**Lyttelton Port of Christchurch Coal Stockyard Expansion Project Response to Further  
Information Request  
Gollans Bay Quarry, Haul Road and Te Awaparahi Bay Stormwater Construction Matters**

Lyttelton Port Company has applied for a suite of resource consents to expand the coal stockyard and the quarrying at Gollans Bay. The Canterbury Regional Council has requested further information under Section 92 of the Resource Management Act, 1991.

The purpose of this letter is to provide answers to those questions relating to construction stage stormwater and erosion and sediment control (ESC). These are Questions 56, 57, 73 - 92 of the further information request, dated 10 March 2010. The report answers the questions in the order contained in the Request.

**G** SECTION: SEDIMENT RETENTION BASIN  
Not to Scale

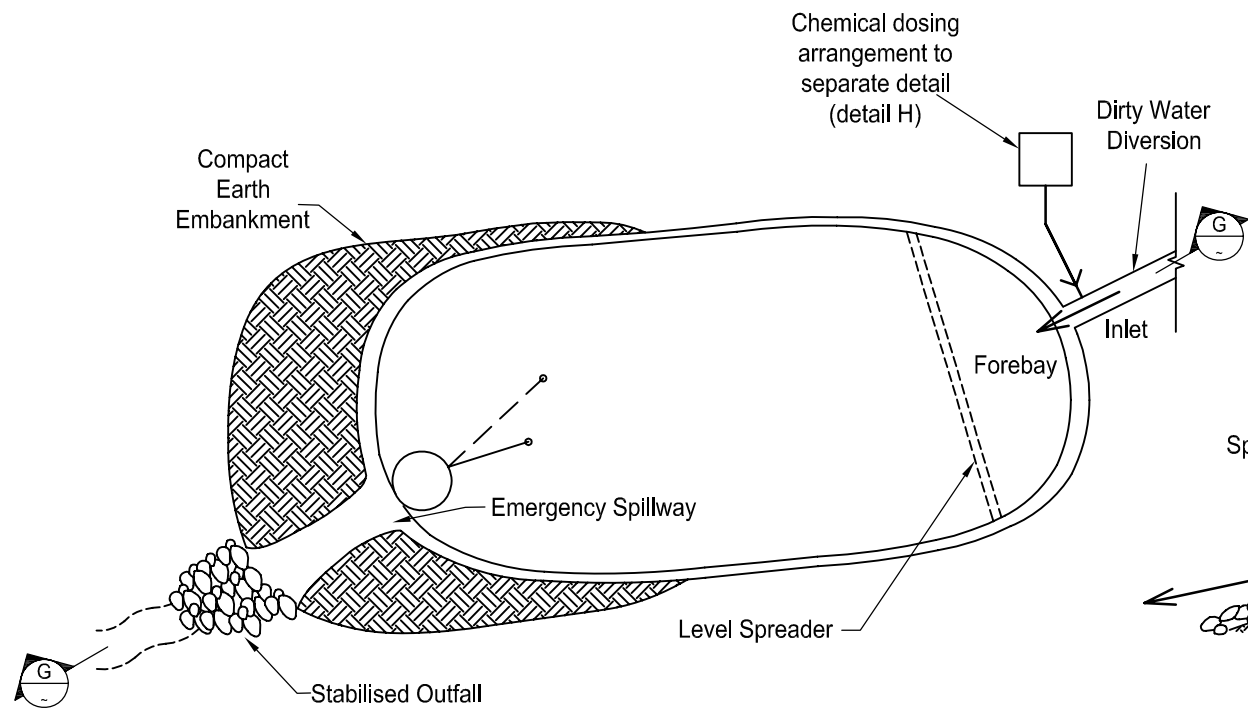
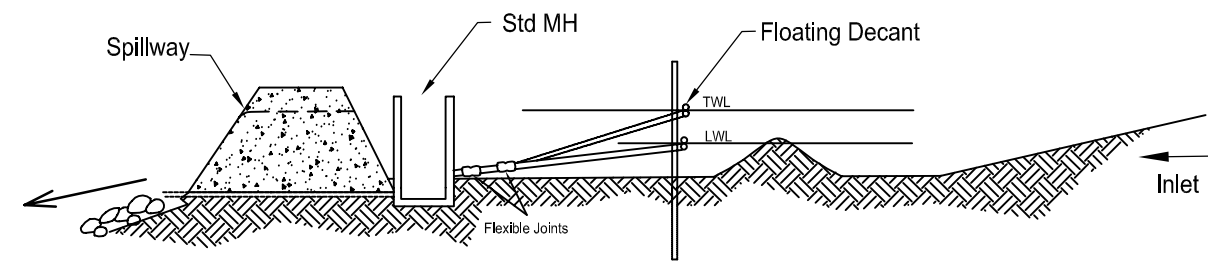
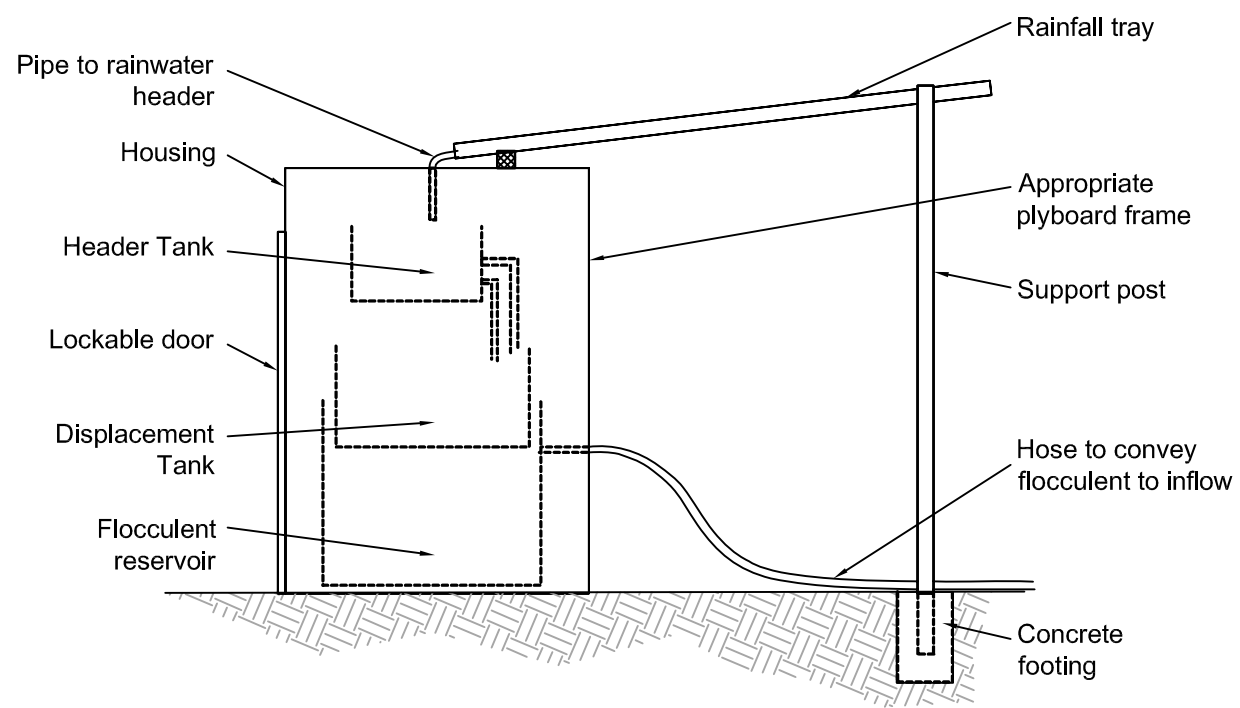
***91. Please provide an assessment and design details of any sediment control ponds proposed, including pond size, decant and spillway design and any proposal for chemical dosing.***

According to the ECan ESCP Guidelines, sediment retention ponds are sized using the runoff from the 10-hour 20 percent AEP rainfall event, which for Banks Peninsula equates to a 70 mm storm. For any given storm, site runoff will vary with soil type and topographic features of the catchment. Guideline values for various soil type and slope within Christchurch area are given in Table 7.5 of the Guidelines. These need adjustments (to higher values) for Bank Peninsula and LPC site conditions. A typical pond design applicable in the Bank Peninsula area is given in CPG Drawing No. 139 based on approximately 525 m<sup>3</sup>/ha storage. This takes into account the higher rainfall depth for the Bank Peninsula area and the revised  $C_v$  of 0.75.

The discharge from the sediment retention pond is controlled by the floating decant system provided. Table 7.6 of ESCG requires 72 holes to be provided for each hectare of contributing catchment based on steep clay with 20% slope. Detail F of CPG Drawing No. 139 Sheet 2 gives the proposed arrangement for a sediment retention pond. The ESCG also provides guidance on the sizing of emergency spillways. The adopted design value is 1.25 m of spillway width per hectare (Table 7.6 ESCG).

**HAUL ROAD EROSION & SEDIMENT CONTROL PLAN CONCEPT**

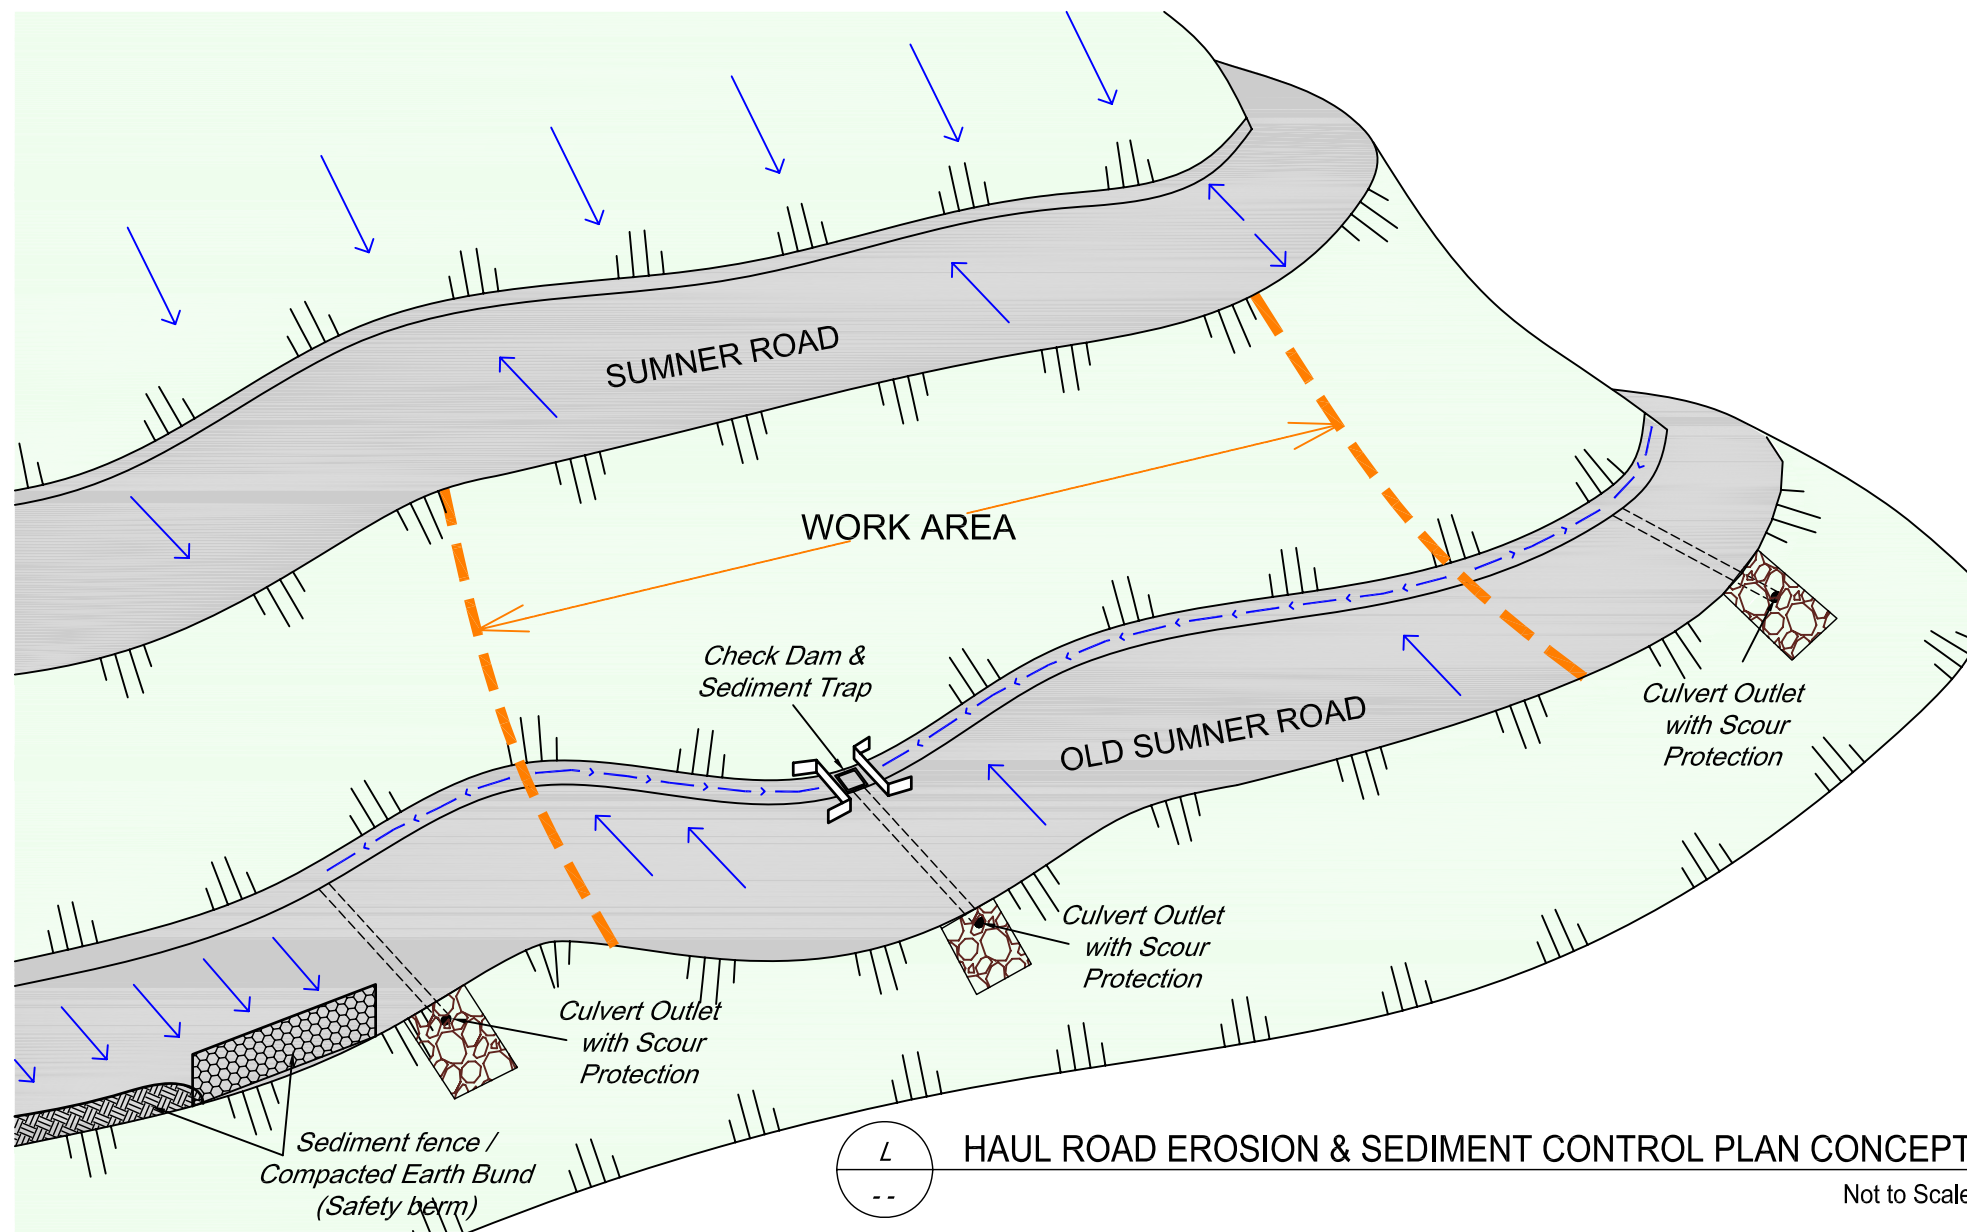
**84. Please provide details of the catchment area for each of the discharge points for the access road, the likely quantity of the loess soils to be excavated and how will they be managed or stockpiled.**

The details of catchment area for each of the discharge points for the haul road will be provided during detailed design, as these are not considered critical at this stage of investigation. It is likely that the existing catchments will not be altered significantly by the road as widening and realignment are minimal. The current culvert locations and gullies are likely to be used. The photo below shows a typical table drain alongside the haul road and Detail L of CPG Drawing No. 140 shows a typical drainage outlet.
